CIRCLIP Vs NUT

Renault Twingo

FI043EU

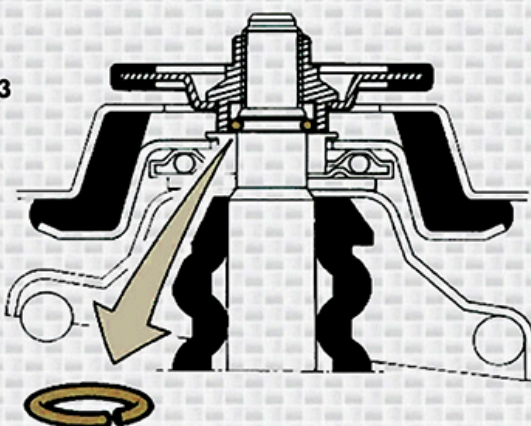
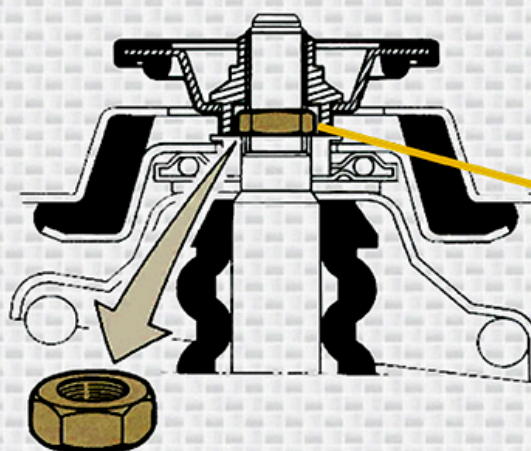
ORIGINAL
... → 12.93

ORIGINAL
1.94 →

Rod nut
Ref. RENAULT
7703032148

Tighten this nut after the car has been placed back on its wheels to prevent rotation of the spring.

TIGHTENING TORQUES	daN.m
Rod nut	6
Intermediate nut	2.5
Lower mounting	11
